Supplementary Submission from the Canadian Coalition for Nuclear Responsibility

To: CNSC Commissioners
From: Gordon Edwards, Ph.D., President,
Canadian Coalition for Nuclear Responsibility (CCNR)
Date: January 13, 2013

Re: ***Failure to provide factual answers to questions posed by the Chairman during the December 3-6 Hearings on the EA for OPG's proposed refurbishment and continued operation of the Darlington reactors.***

Re: The Unavailability of CANDU safety systems

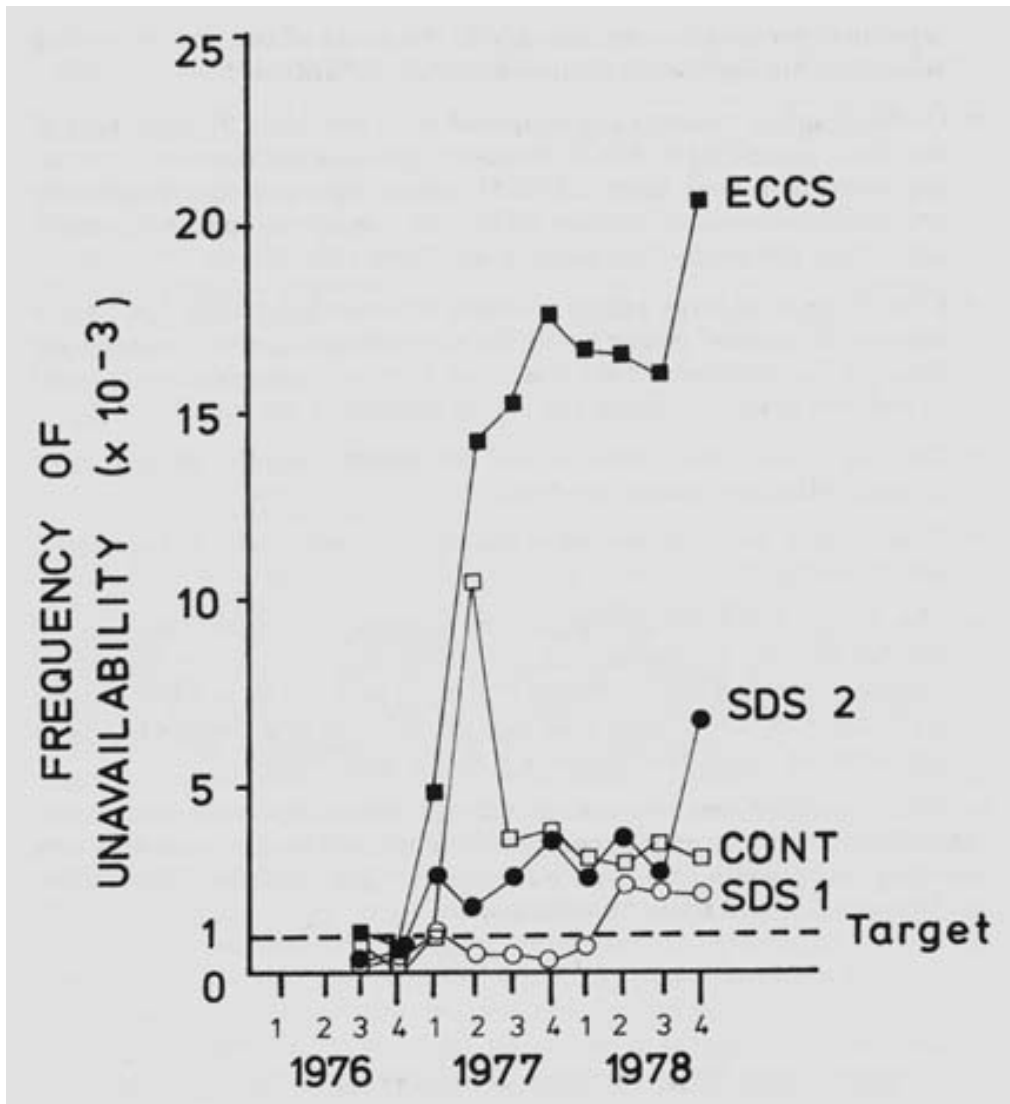
(24) The chart shows that both shutdown systems were occasionally unavailable during operation, often for hours, during those years. As pointed out by Mr. Webster in the December 6 Transcript, all four principal safety systems are required to be unavailable no more than one one-thousandth of the time. So each safety system is "allowed" to be unavailable for not more than 7 hours per year, assuming an 80 % capacity factor – or 9 hours per year, assuming the plant never shuts down, even for maintenance. (Incidentally, this means that Mr. Webster's earlier comment that unavailabilities have to be corrected within 24 hours is totally out of line with the 7 to 9-hour regulatory targets governing the allowed unavailability of safety systems.)

(25) In any event, the AECB chart shows that in 1978 each of the four safety systems at Bruce "A" NGS – including the two shutdown systems – was unavailable for much longer periods of time than allowed in 3 of the 4 reactor units. In unit 4, for example, the second shutdown system (SDS-2) was unavailable for about 50 hours in 1978, while the first shutdown system (SDS-1) was unavailable for more than 15 hours. Meanwhile, the containment in unit 4 was unavailable for about 20 hours, and the emergency cooling system was unavailable for more than 147 hours – almost a week.

(26) In all four Bruce "A" units, the chart shows that SDS-2 was unavailable for more than 10 hours per year in both 1977 and 1978. In three of the four units, SDS-1 was

also unavailable for more than 10 hours in 1978. The other two safety systems – emergency cooling and containment – were unavailable much more often than the target throughout the entire two-year time period 1977-78. This past experience is in sharp contrast to what Mr. Webster says of the Darlington reactors, that “*special safety systems, all four, have to meet a target of 10 to the minus 3 – that is they must be unavailable less than one one-thousandth of the time.*” This claim deserves checking.

In my testimony I mentioned that the two independent fast shutdown systems that are a feature of all operating CANDU reactors have not always been available even during operation.

I believe this statement by Mr. Jammal to be untrue. Moreover I find it disturbing that Mr. Jammal would misinform the Commissioners on such an important topic, especially when this becomes enshrined as a matter of record in the transcript of the hearing.
